DOES THIS BEAM MAKE MY BUILDING LOOK TOO HEAVY?

BY CARLO LINI

IMAGINE THAT YOU ARE HAVING a conversation with a colleague about a project and you've been asked to give your opinion on a structural framing layout that they've put together. Let's say that the portion of the floor plan provided below, along with the detail and structural steel notes on the following page, is part of the project that's being discussed. What might you do differently?

▲ Axial Connection Detail

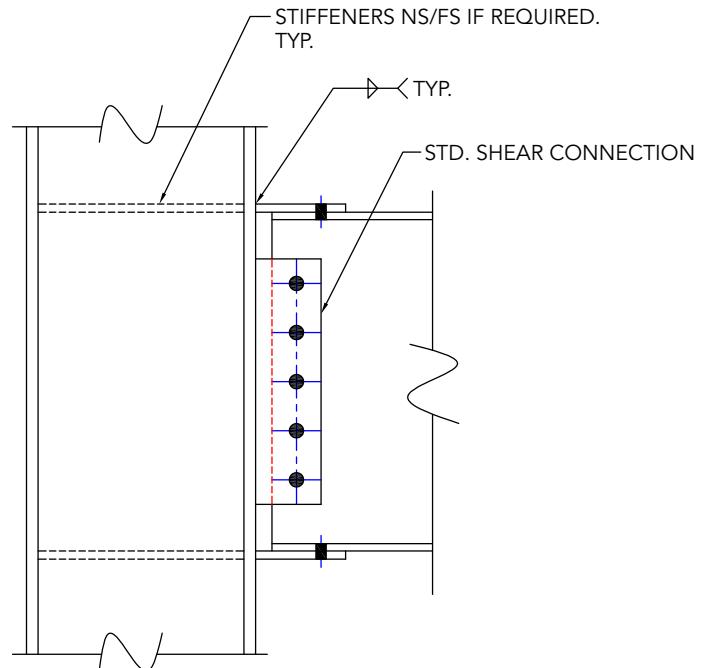
9. We have a detail that doesn't work for the way the joint was analyzed. The axial connection detail provided on the structural drawings is a fully restrained moment connection, meaning that there is also going to be moment that needs to be transferred. However, the drawings show a joint with shear and axial force only. Either the moment needs to be provided on the framing plans or the axial connection detail needs to be modified. For example, a single-plate shear connection can be used to transfer the shear and axial load (no paddle plates and no moment).

► Fig. 1: Deep-beam-to-shallow-girder connection.

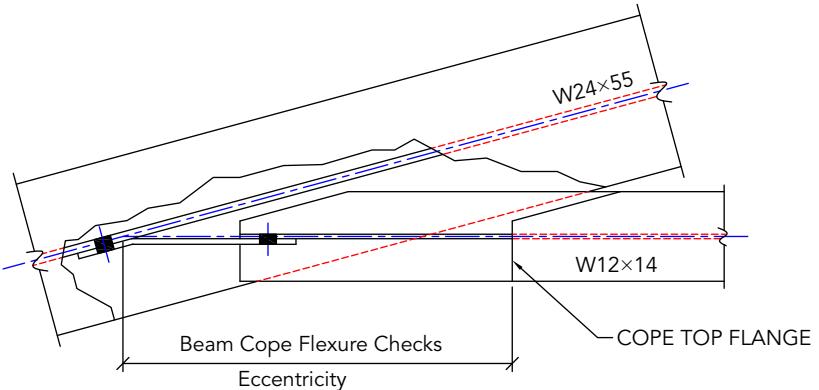
1. Eliminate interference at deep beams into shallow girders. Consider connection difficulty versus the cost of increasing a beam to the next size. In this particular case, upsizing the W14×22 to a W16×26 provides some breathing room (see Figure 1) at a cost of about \$25 per beam, assuming steel costs \$0.45/lb. This will be far less than the labor involved to make a beam fit if the angles foul on the flange or fillet and don't seat freely at the bottom.

▲ Fig. 3: Skewed beam framing option.

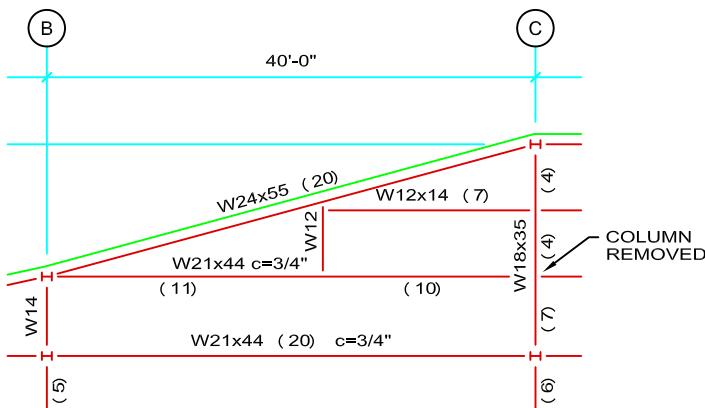
4. Change the details at large skews. This is particularly important for shallow beams and beams with large end reactions. This can result in extended shear tabs with thick plates, large welds and extra bolts. Increasing the W12 to a W14 or W16 may help simplify the connection, resulting in a more reasonable shear tab plate thicknesses and weld sizes along with possibly reducing the number of bolts required. If the beam is coped (see Figure 2), reinforcing may be required due to the cope length and shallow beam depth. Increasing the beam depth to avoid beam reinforcement may be a better option.

Another option is to add an additional framing member perpendicular to the direction of the W12 beam. Doing this will simplify the connection for the W12 along with providing a much easier skew connection to the W24×55 (see Figure 3).

▲ Fig. 4: Increased beam spacing.

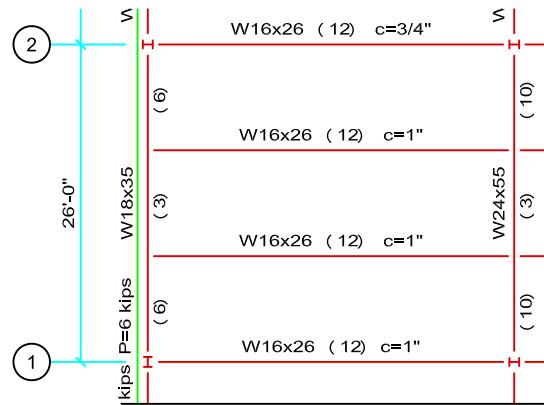
10. Can we increase the beam spacing and have fewer infill beams? When possible, take advantage of the strength of the floor slab and increase the beam spacing. In this case, a 2-in. composite metal deck (20 ga) with 4½-in. normal weight concrete can span unshored up to 9 ft, 0 in. clear and still meet the superimposed loading requirements. Using the strength of the floor slab, two beams can be removed per bay (see Figure 4), which results in a decrease in tonnage of about 1.5 psf for the bay shown, along with fewer pieces to detail, fabricate and erect.

▲ Fig. 5: Complicated beam to column connections.

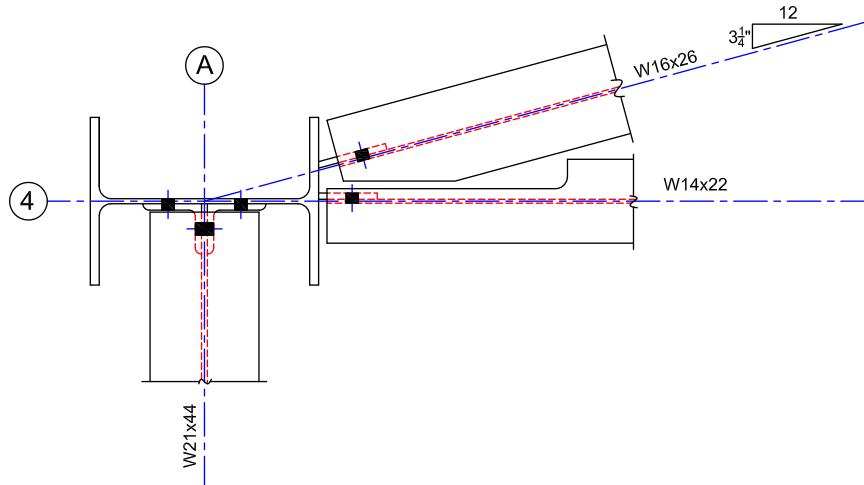
16. Can the details be modified to simplify beam-to-column connections? Try to lay out the floor framing in a way that limits or eliminates complicated connection details. The original layout had a complicated beam-to-column connection at columns A/4 and B/5 (see Figure 5). Although there are several different ways of fabricating the ends of these beams such that the flanges clear each other, some blocking, compound cuts or some combination thereof would be required to allow fit-up. Furthermore, access for providing the welds of the single-plate shear connections to the column flange is tight. Note also the inherent eccentricity induced as a result of where the spandrel beam connection intersects the column flange. This induces a biaxial moment into the column that more than likely was not accounted for in the analysis.

By changing the orientation of the framing (as shown in Figure 6) and changing the column orientation to line up with the spandrel beams, the complicated connection details are eliminated along with the biaxial moment in the column. From a cost standpoint, this change would have little to no impact on the cost of the steel, but would significantly simplify the design of the connections and reduce the labor involved in prepping the ends of the members.
